UNITED STATES PATENT AND TRADEMARK OFFICE

10/812,086

Office Action Summary	Application No. 10/812,086	Applicant(s) MAKINO ET AL.	
	Examiner KARLA MOORE	Art Unit 1792

DETAILED ACTION

Figure 1 of Lappen

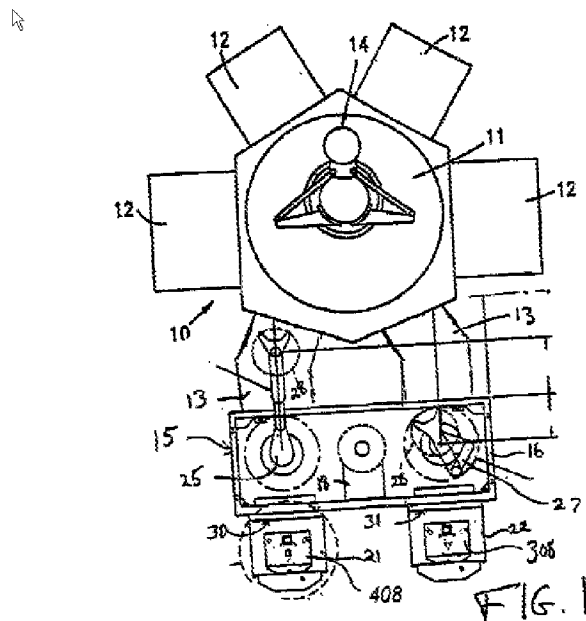
as claimed and comprising: a transfer box (Lappen, Figure 1, 15) inside or which an object wafer to be processed is transferred under an atmospheric condition by a transfer robot (Lappen, Figure 1, 25 and 27) disposed therein, the transfer box having a plurality of cassettes (Lappen, Figure 1, 21 and 22) installed at a front side portion thereof; a vacuum transfer unit (Lappen, Figure 1, 11) disposed at a back side portion of the transfer box and coupled to a back side surface portion of the transfer box, the vacuum transfer unit enabling transfer of the object wafer therein under a vacuum condition; at least one vacuum processing chamber (Lappen, Figure 1, 12) disposed a back or lateral side of the vacuum transfer unit and being connected thereto (via load lock chambers 13), the at least one vacuum processing chamber being supplied with gas and enabling processing of the object wafer transferred under the vacuum condition by a plasma generated therein; and a plurality of connector portions (at facilities integration plate Figures 1-3, 100 in Reinke) of utility paths which connect with paths arranged in another floor of a building different from a floor of the building in which the vacuum processing apparatus¹ is installed so that the at least one vacuum processing chamber is disposed above the floor, the plurality of connector portions being disposed substantially so as to extend substantially linearly under a connecting portion (Lappen, Figure 1, 13) of the vacuum transfer unit and the back side surface of the transfer box and along the back side surface, wherein the utility paths enable supply of utilities including the gas

10. Each of the above Figures is of a Centura semiconductor processing tool manufactured by Applied Materials (for example, see Paragraphs 2 and 3 of Lappen and column 2, rows 44-55 of Reinke). In Reinke, the provision of a facilities integration plate (100) provided below an area which would correspond to an area in Lappen under the connection portion between the transfer box (factory interface, 304) and a vacuum

11. Regarding claim 13, the disclosures by Reinke et al. and Lappen et al. can also be characterized as disclosing a vacuum processing apparatus substantially as claimed and comprising: at atmospheric block (Lappen, Figure 1, 15) including a transfer box inside of which an object wafer to be processed is transferred under an atmospheric condition by a transfer robot (Lappen, Figure 1, 25 and 27) disposed therein, the transfer box enabling holding of a plurality of wafer cassettes (Lappen, Figure 1, 21 and 22) installed at a front side surface portion thereof; a vacuum processing block (Lappen, Figure 1, 11 and 12) installed at a connecting portion (Lappen, Figure 1, 13) of the vacuum transfer unit and the transfer box, wherein the vacuum processing block comprises: a vacuum transfer unit (Lappen, Figure 1, 11) disposed at a back side of a back side surface portion of the transfer box and connected thereto by a connection portion thereof (via load locks 13), the vacuum transfer unit enabling transfer of the object wafer therein under a vacuum condition and a plurality of vacuum processing chambers (12) being disposed at a rear back or lateral side of the vacuum transfer unit and being connected thereto, at least one of the vacuum processing chambers being supplied with gas and enabling processing of the object wafer transferred under the vacuum condition by a plasma generated therein; and a plurality of connector portions (at facilities integration plate Figures 1-3, 100 in Reinke) of utility paths which connect with utility paths arranged in another floor of the building in which the vacuum

17. With respect to claims 17 and 22, as described above, the connector portions of the utility paths are disposed under at least one load lock chamber (13) consisting of the connection portion between the transfer box and the vacuum transfer unit.

Figure 3 of Reinke

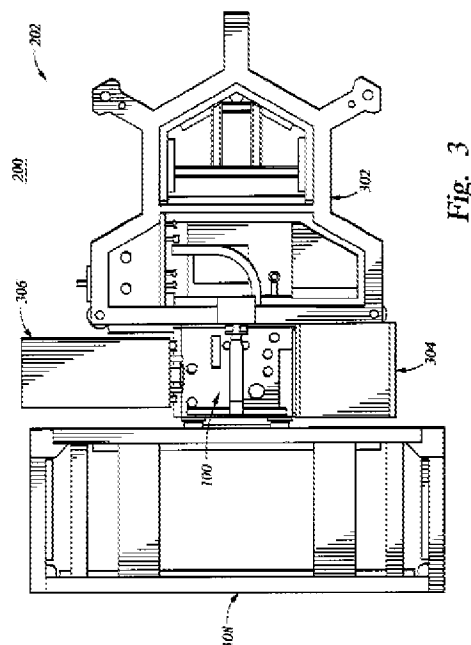
transfer unit (not explicitly called out in Reinke, but corresponding to the area labeled "Vacuum Processing Block", above) is disclosed (for example, see Figures 2 and 3 and column 3, rows 51-59).

24. Applicant has argued that the combination of Reinke and Lappen fail to disclose the plurality of connector portions of the utility paths being disposed so as to extend substantially linearly above the floor of the building. Examiner disagrees. Examiner finds that Figure 2 or Reinke fairly suggests at least portions of the plurality of connector portions extending linearly above the floor of the building. Thus, the prior art anticipates the claimed invention of the plurality of connector portions extending substantially linearly above the floor of the building.
